Subject: Chula Vista Energy Upgrade Project (07-AFC-4)  
Response to Environmental Health Coalition Data Requests 1 through 35

**Response to Environmental Health Coalition  
Data Requests 1 through 35**

**Chula Vista Energy Upgrade Project**  
Chula Vista, California  
(07-AFC-4)

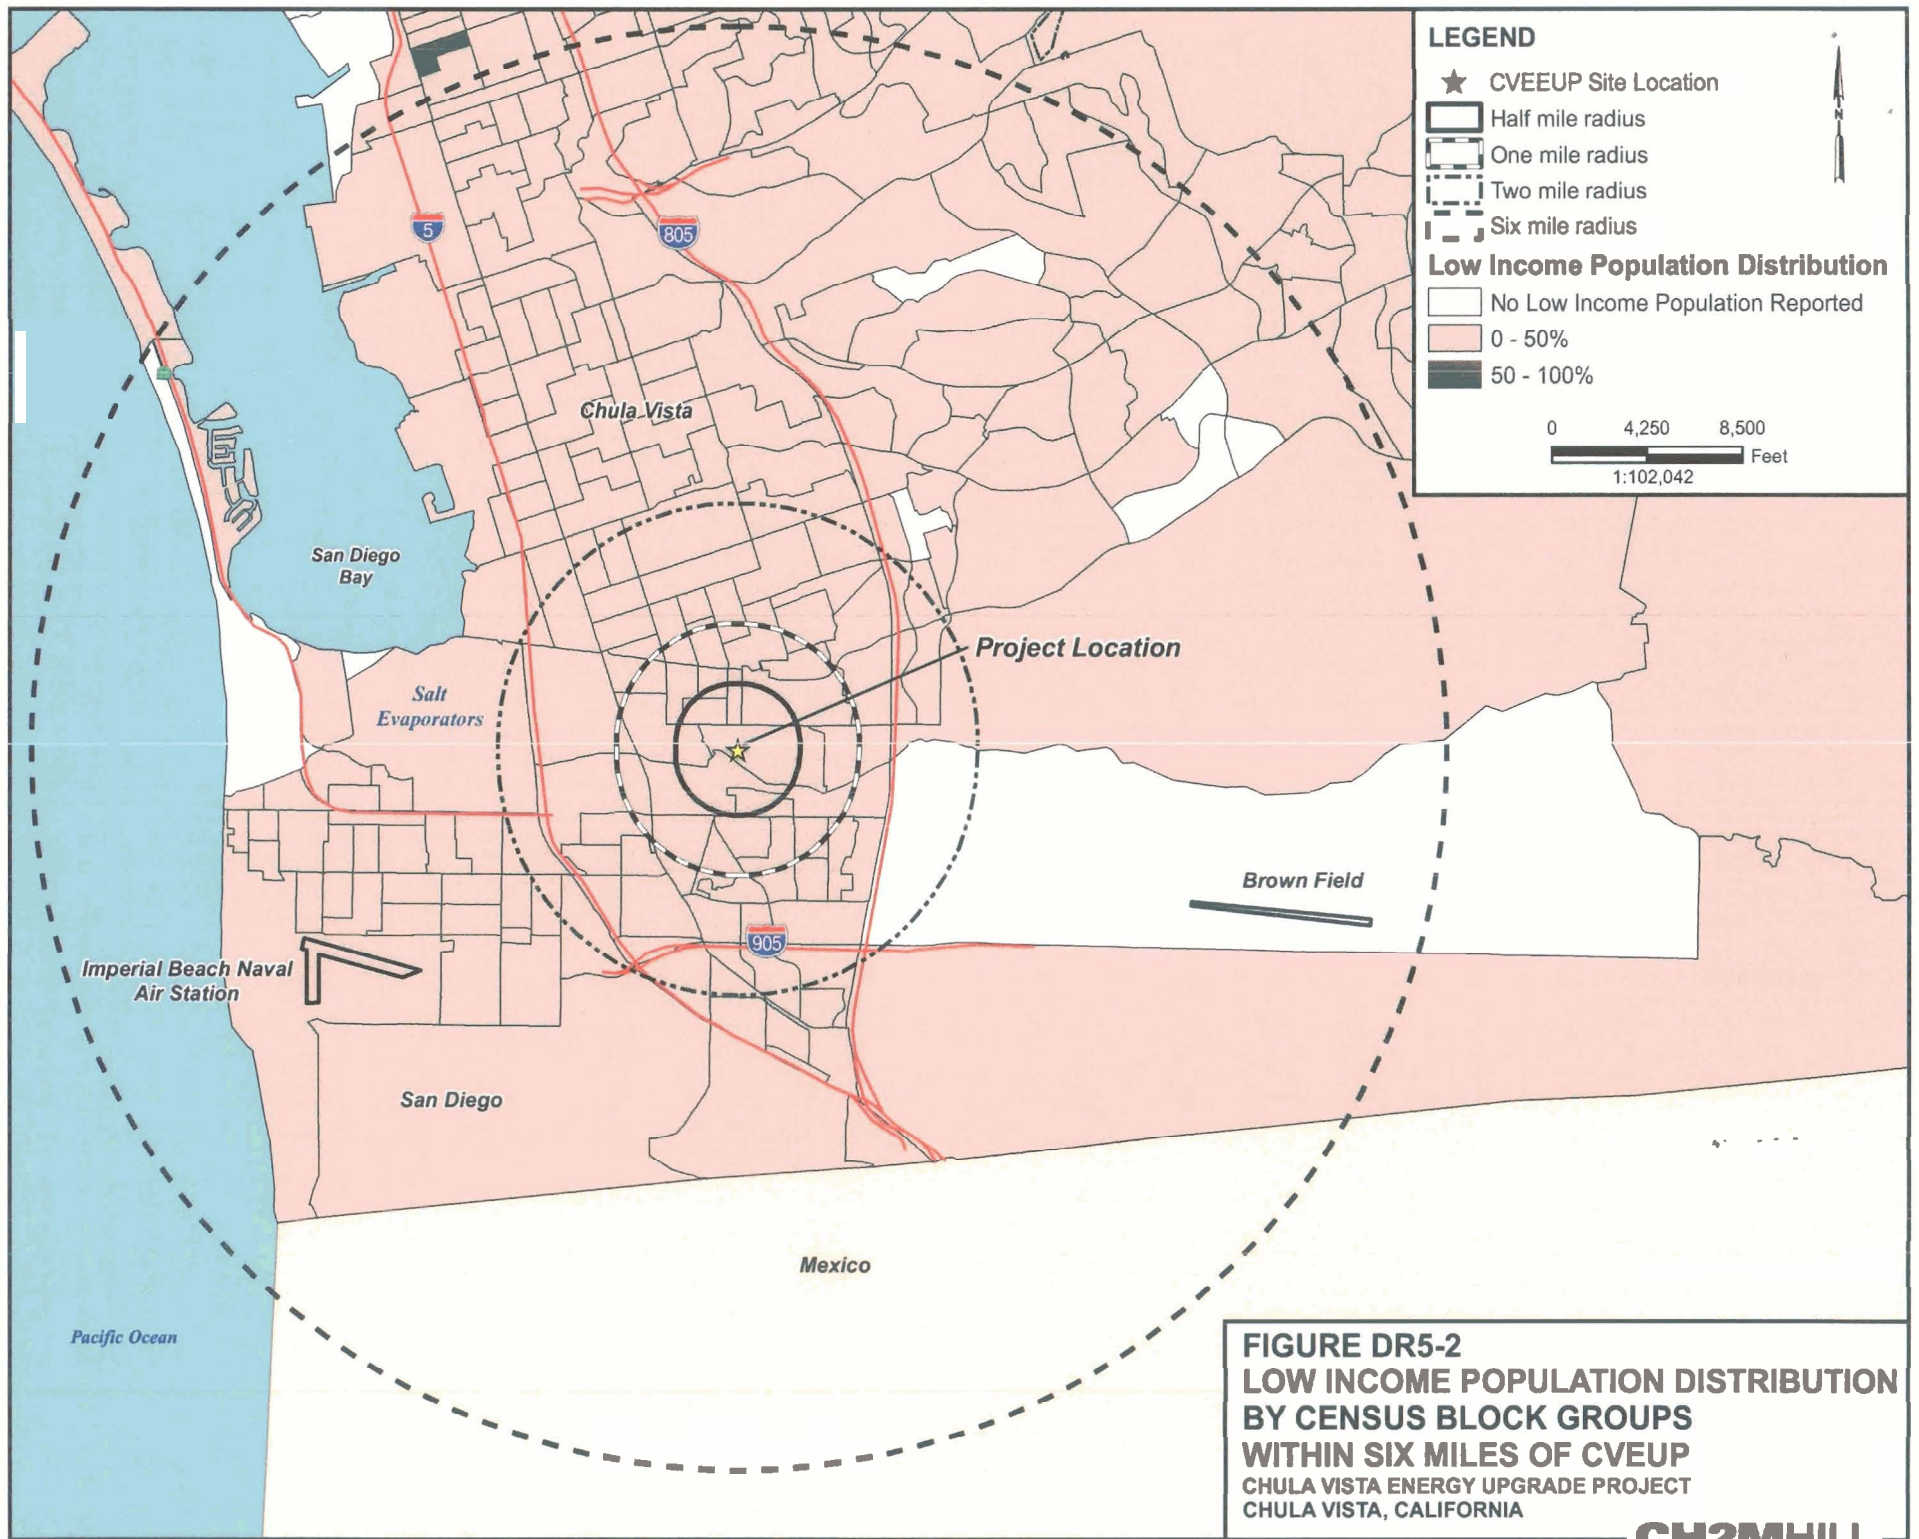
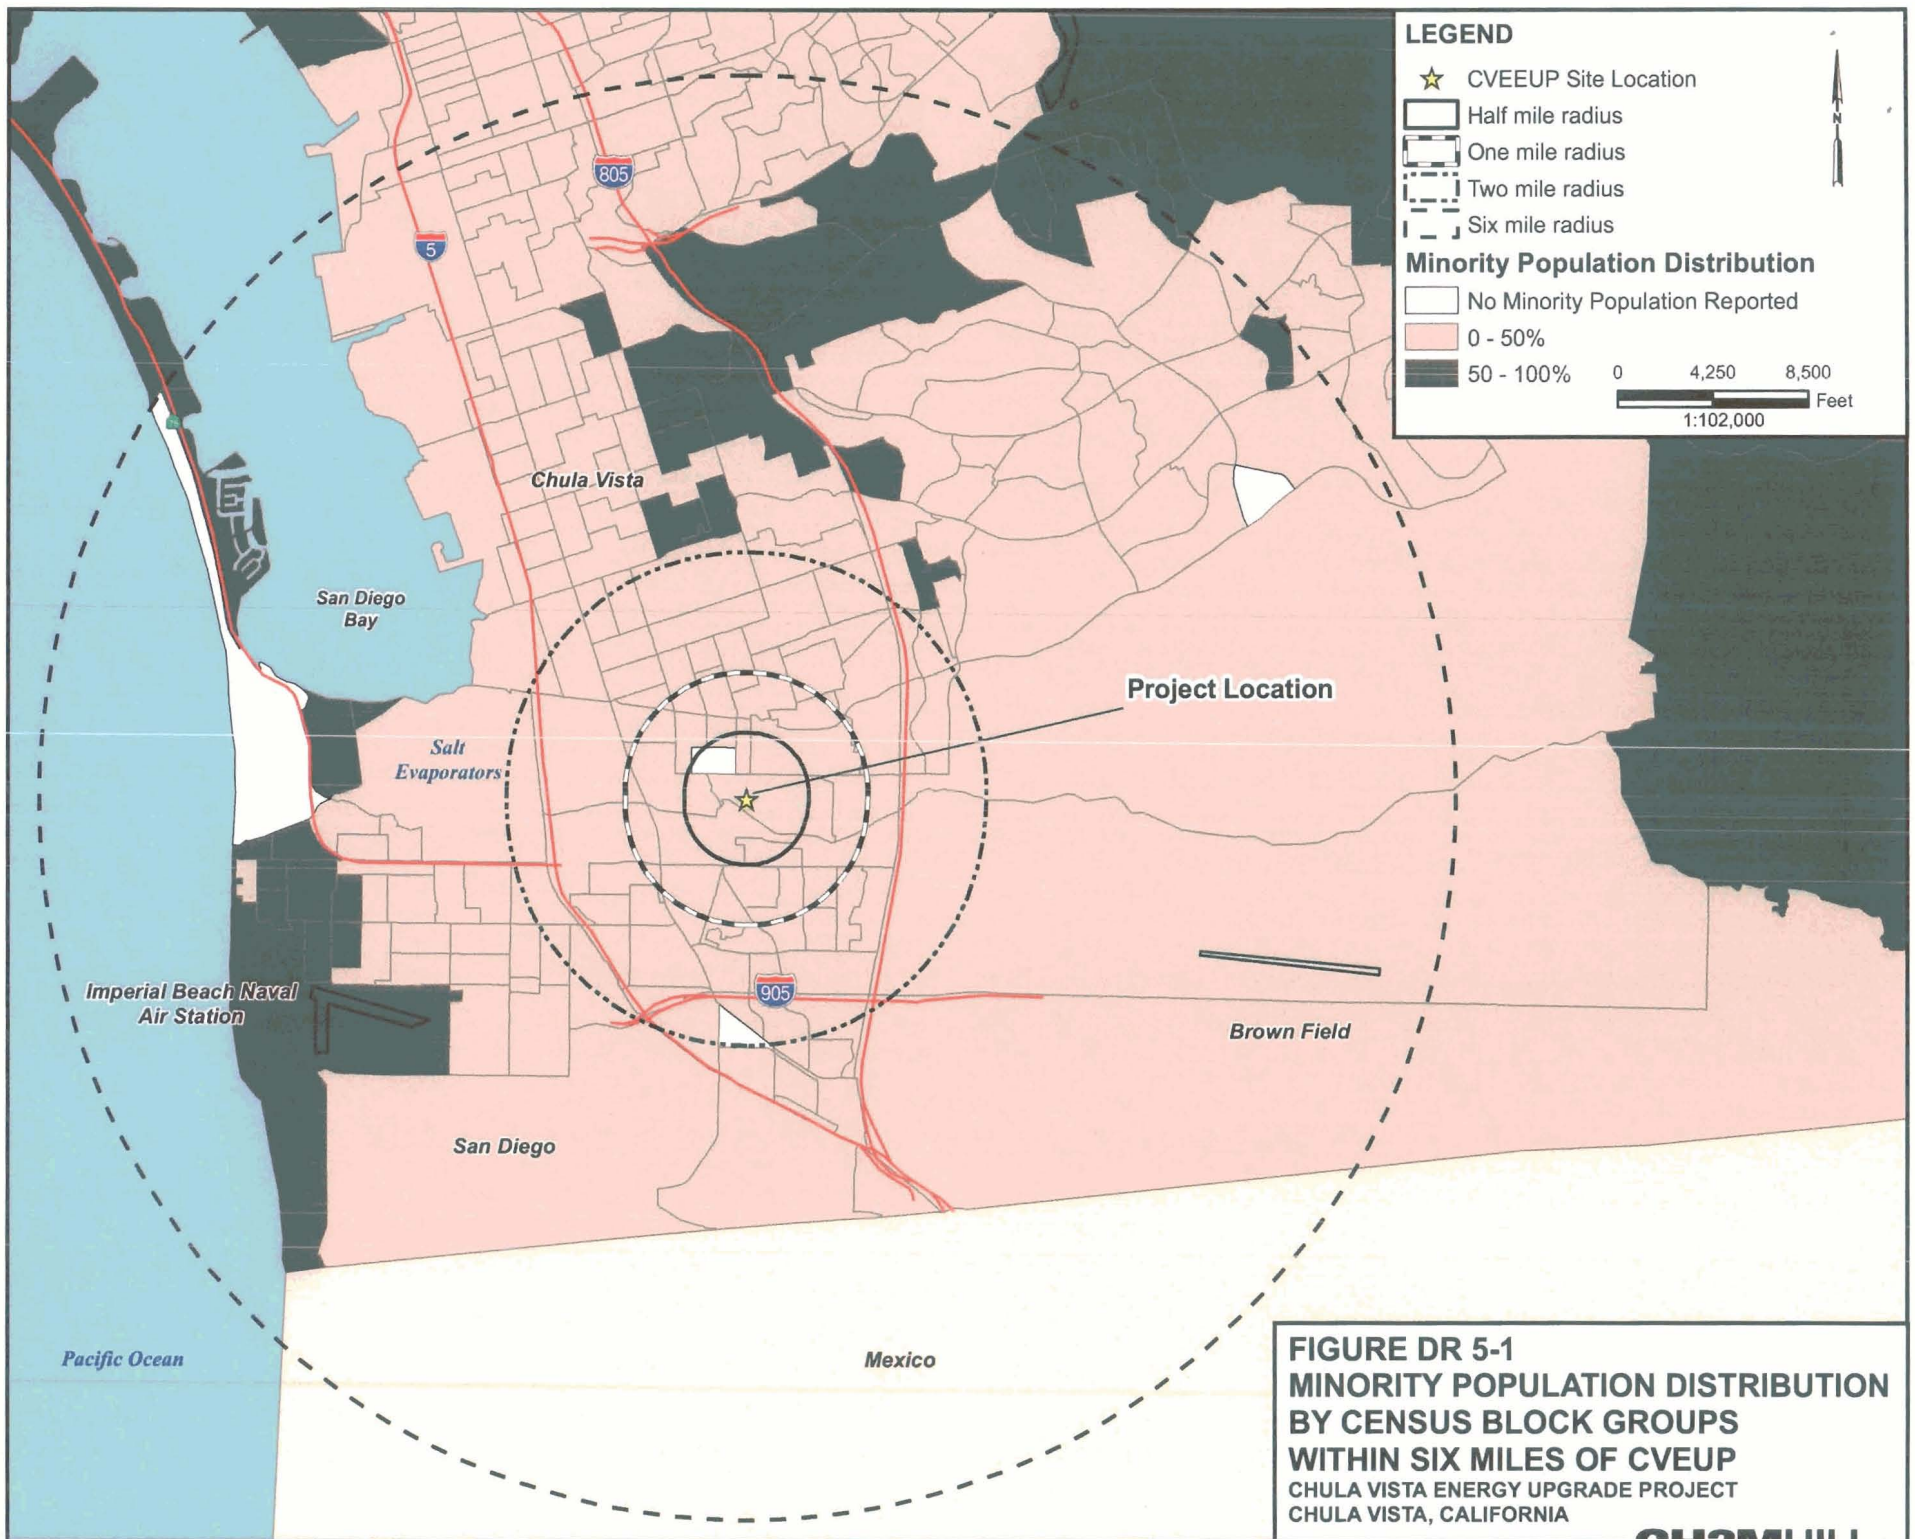
5. *Please provide a more accurate demographic study of the surrounding community. Provide current economic and ethnic information for community residents and workers within 0.5 miles, within 1 mile, and within 2 miles.*

**Response:** The analysis provided in the Application for Certification is based on US Census Bureau data (see AFC Section 5.10.2.4.9 and Appendix 5.10A) and is accurate to the limits of this data source. Appendix 5.10A of the AFC contains minority and poverty population data by Census Block Group (CBG) for all CBG's within six miles of the project site. The radius of six miles was chosen because this is the distance that the CEC Staff has, in previous siting cases, defined as the radius of potential public health effects resulting from air emissions (per CEC Data Adequacy requirements). Maps identifying the 0.5-mile, 1-mile and 2-mile radii for both the Minority Population Distribution by Census Block Groups and Low Income Population Distribution by Census Block Groups are included here as Figures DR5-1 and DR5-2, respectively.
